FIXING PROBLEMS CONCERNING FRONT PANELS

Up to serial no.725xxxxx, on the appliances listed in Tab. A, there might happen that the front panels could appear misaligned due to an excessive backlash when closing back the panel.

FIGURE 1

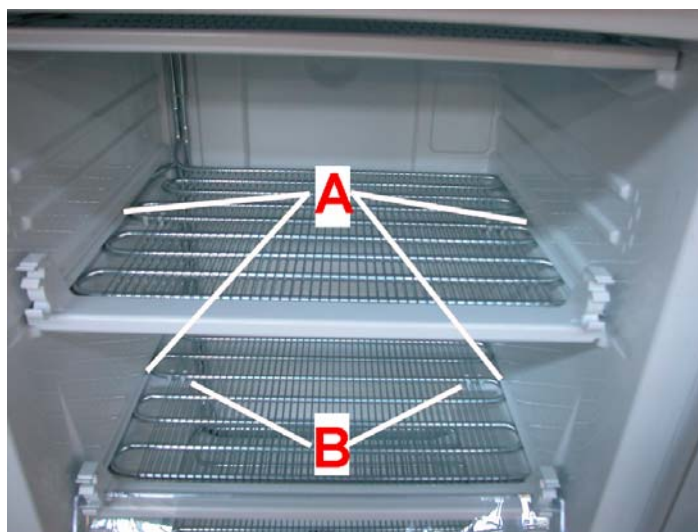
To improve the fixing of the front panels, it is necessary to use 4 trims (component A – fig. 1) and 2 evaporator stops (component B – fig. 1) and place them as shown in figure 2. The spare part nos. are listed hereafter.
